## 8.6 Non-Governmental Organization Comments and Responses

### **First Letter of Objection to Monterey Peninsula Water Supply Project (MPWSP) CalAm's defective and incomplete draft EIR/EIS**

Figure 2. Slant Well Patent, 2011,<sup>32</sup> showing the inflow directly above the submersible pump. The presented upside down bell curve (red arrow), is the anticipated pumping profile through the sea floor. More elaboration about induced infiltration can be found in Williams 2015.<sup>33</sup>

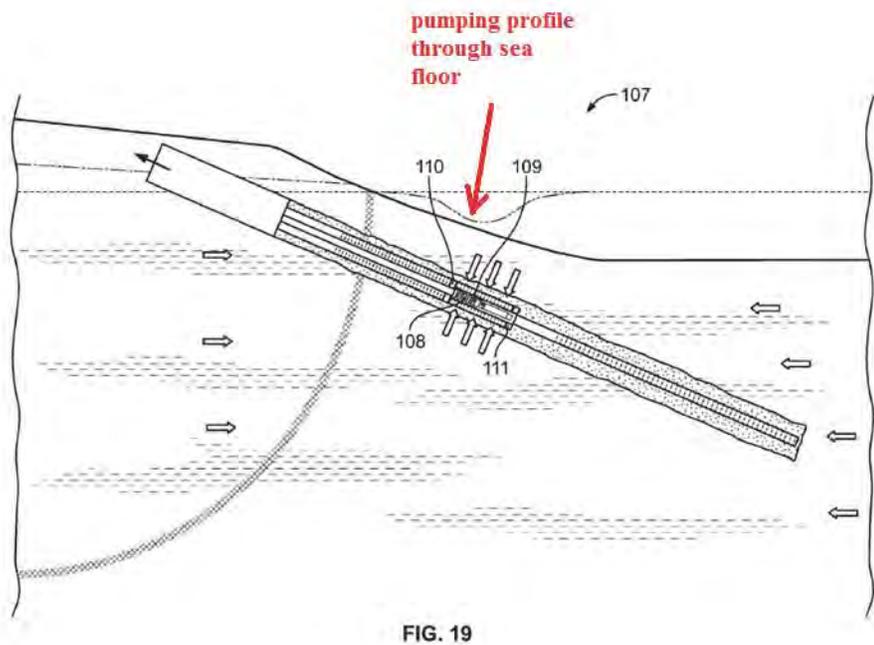
Utilizing the DEIR/EIS’s maps and the models below, we have determined that most of the water will be drawn through this older dune sand, which is highly permeable and closest to the submersible pump, thus rendering only the upper third, approximately, of the well productive, unless the packers will be engaged.<sup>41</sup> Without additional details, which the DEIR/EIS does not provide, it is difficult to estimate the intake zone. Well’s location figure 14 (see Appendix section in this report) is departing from conceptual presentations in figure 4, patent US 8,056,629 B2, William’s 2015 white paper.

**Figure 4. Geological cross section through the project site. The drawings aspect ratio has not been preserved.<sup>36</sup>**

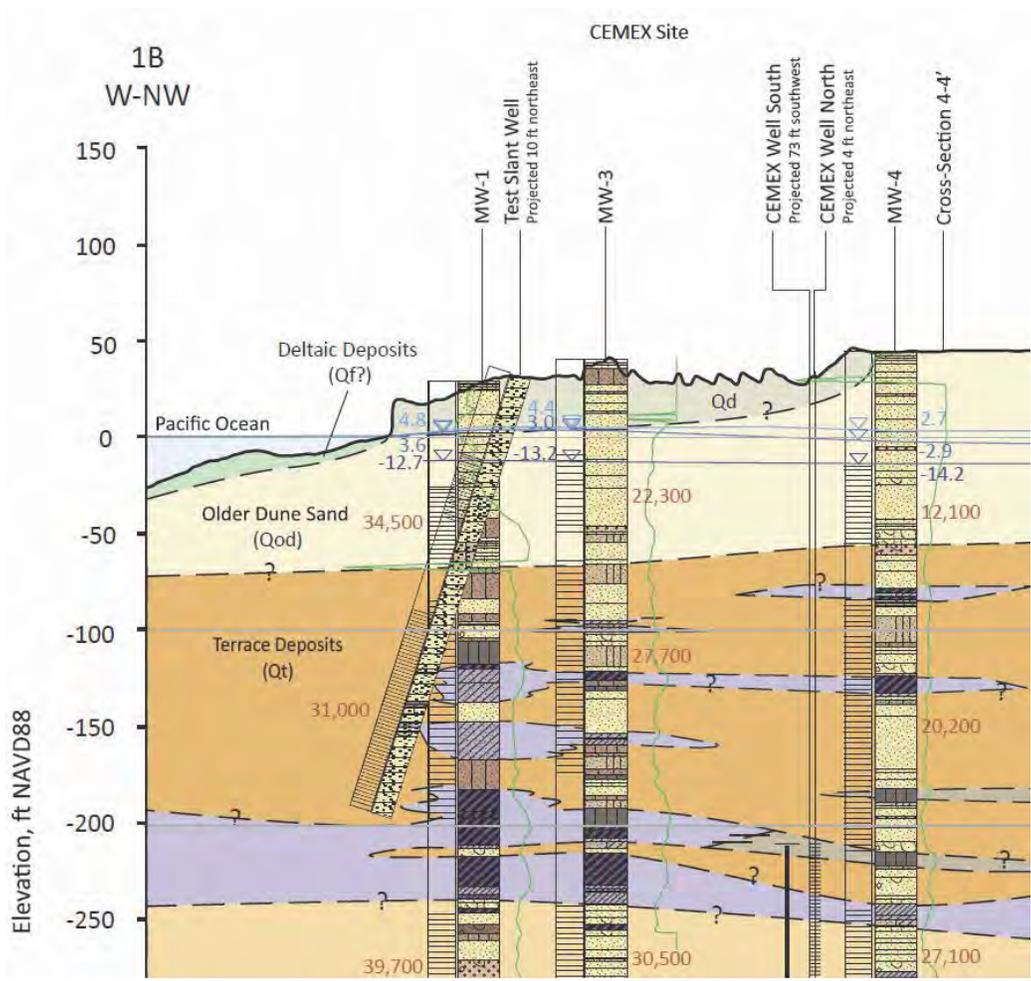
Note, however, that this picture does not preserve the actual angle the test slant well was designed to operate at. When accounting for the approximate 19 degree angle, the picture of the slant well becomes clearer.

**Figure 5. Regenerated aspect ratio of the hydro-geological cross section based on 4.2-9 CalAm MPWSP DEIR/EIS Chapter 4 for the test slant well.<sup>37</sup> Restoration of aspect ratio gives better perception of the hydro geological composition.**

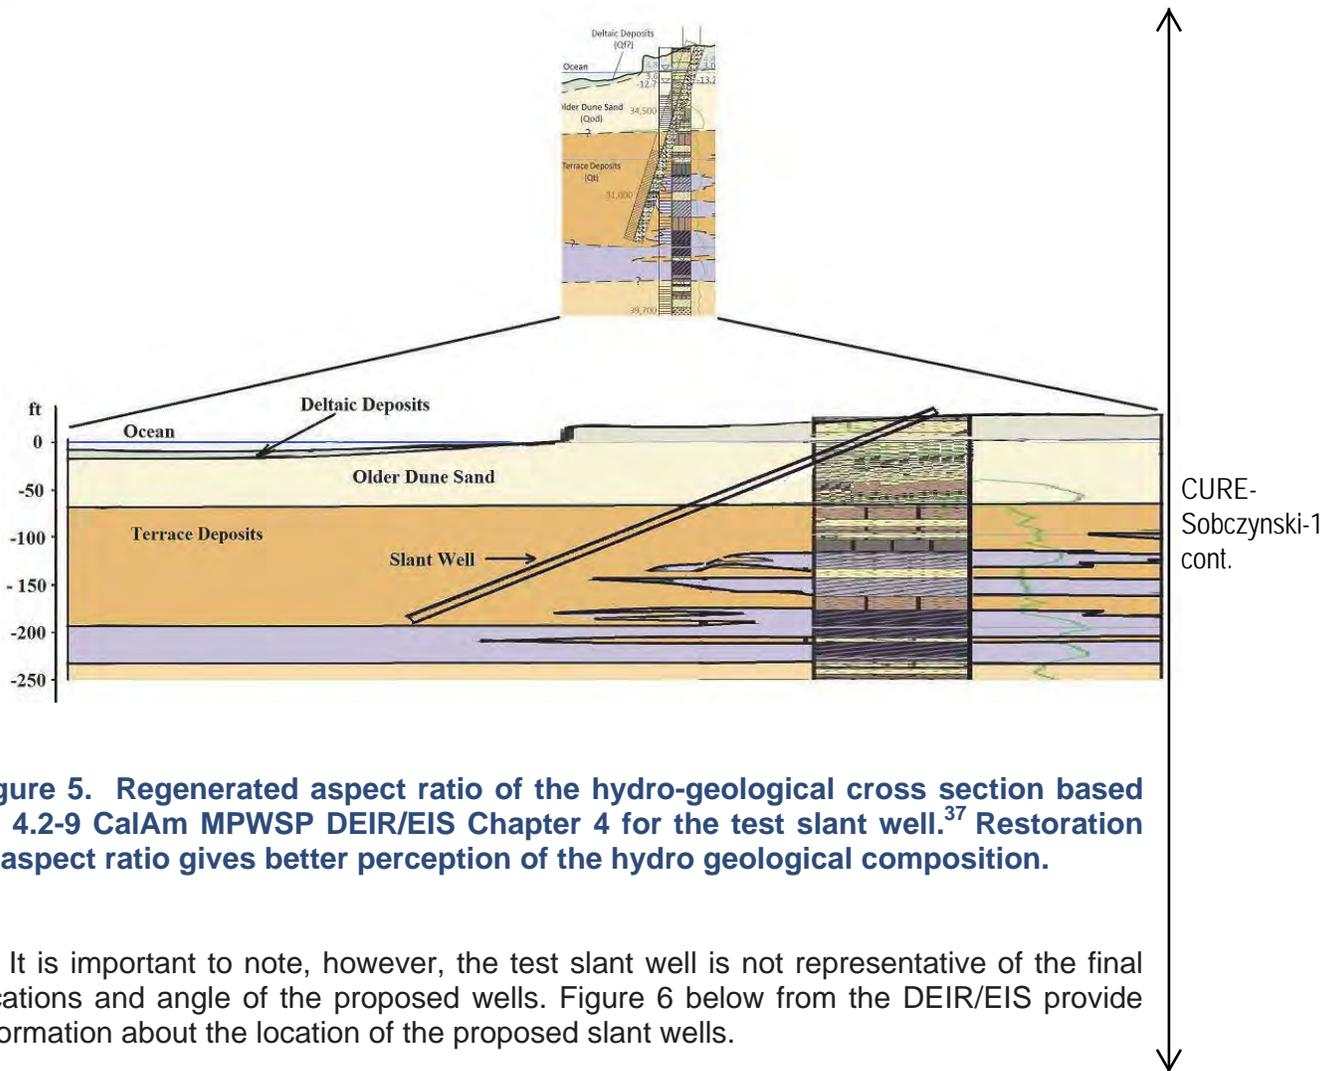
It is important to note, however, the test slant well is not representative of the final locations and angle of the proposed wells. Figure 6 below from the DEIR/EIS provide information about the location of the proposed slant wells.

205335.01 Monterey Peninsula Water Supply Project  
Figure 3-3a  
MPWSP Seawater Intake System

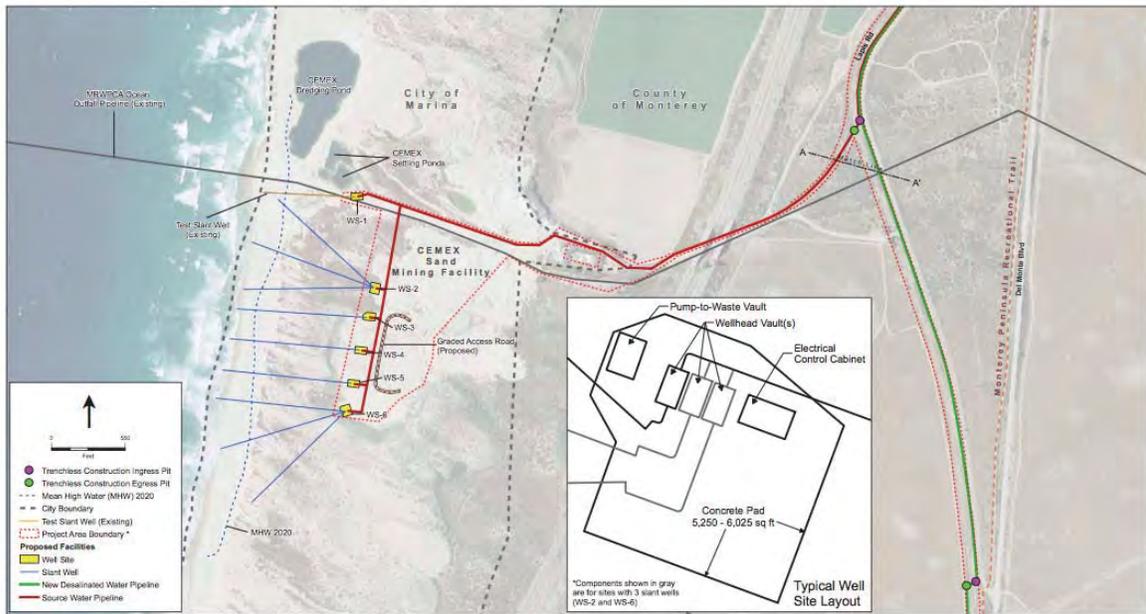
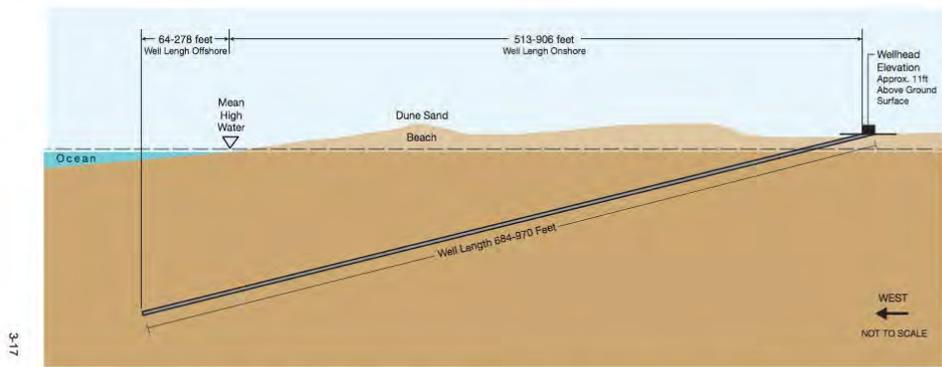
25.	3.2.1 Seawater Intake System	3-13	Figure 3-3a	We believe some minor corrections to this Figure are necessary to show the current slant well layout.	See redlined figures provided. Please see Attachment A to this chart for corrections to this Figure.	CalAm-25

26.	3.2.1 Seawater Intake	3-13	Figure 3-3a	Sizing and specific project components require minor clarifications in this Figure.	We request the following additional minor clarifications to the Figure:

28.	3.2.1.1 Subsurface Slant Wells	3-17	Figure 3-3b	The lengths listed for onshore and offshore well lengths appear to require minor corrections. Please see table attached as Attachment C to this chart for values calculated by GEOSCIENCE (and refer to Attachment A – marked-up Figure 3-3a for well naming used for measurements/calculations). The updated well layout was used for the measurements. For comparison, lengths were calculated for current (2015) Mean High Water and the 2020 MHW used on Figure 3-3a.	The markups, from north to south, are: SW-1 Stand-by-1 SW-2 SW-3 SW-4 SW-5 SW-6 SW-7 Stand-by-2 Stand-by-3
